KURT ALLEN FISHER
P.O.B. 11753
Salt Lake City, Utah 84147-0753
fisherka@csolutions.net
(801) 414-1607 (cell)
June 4, 2019

Historic Landmark Commission
SALT LAKE CITY CORPORATION
451 South State Street, Room 326
Salt Lake City, Utah 84111

Re: 4th Avenue Well's Failure to Comply with Salt Lake Code Requirements
Comment to Historic Land Commission ("HLC") on 4th Avenue Pump Applications by the Department of Public Utilities ("DPU") at approximately 200 North Canyon Road, Salt Lake City, Utah (the "Well")¹. HLC PLNHLC2018-00557 and PLNHLC2018-00558

A – ATC Report on Seismic Risk Design Classification

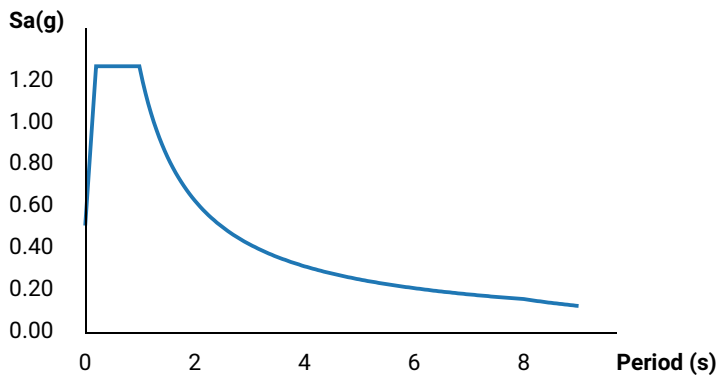
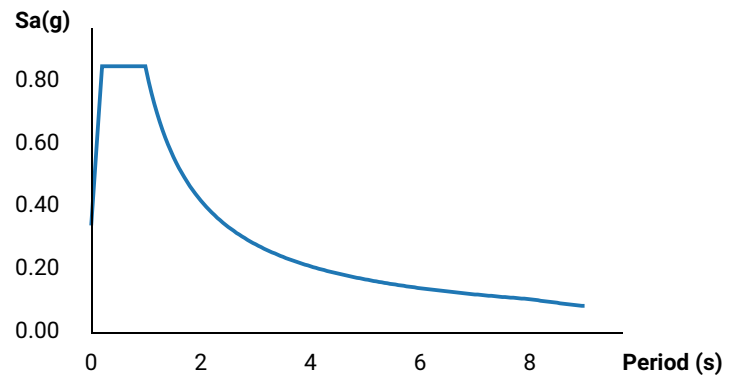
The second type of IBC classification related seismic risk at the proposed Well site is based on expected ground accelerations from national maps. Seismic Design Class A has the lowest accelerations during an earthquake; Class F the highest anticipated accelerations. Various online calculators simplify the process of determining risk and load factors applicable to a United States address.¹⁸ The Applied Technology Council seismic map risk calculator indicates that the proposed 4th Avenue Well site is Seismic Class D.¹⁹

Under Section 1803 of the IBC, a *building official* must require a geotechnical analysis of the risk of seismic shaking and liquefaction for any Class D site.

In the instant matter, the Zoning Administrator had the discretionary power to request an early site-specific geotechnical assessment. One will be required in subsequent building permit proceedings. Your commentator has provided sufficient evidence in the record as to unique seismic risks that may be accounted for by national maps. No site specific geotechnical report appears in the Briefing Materials before the Commission.
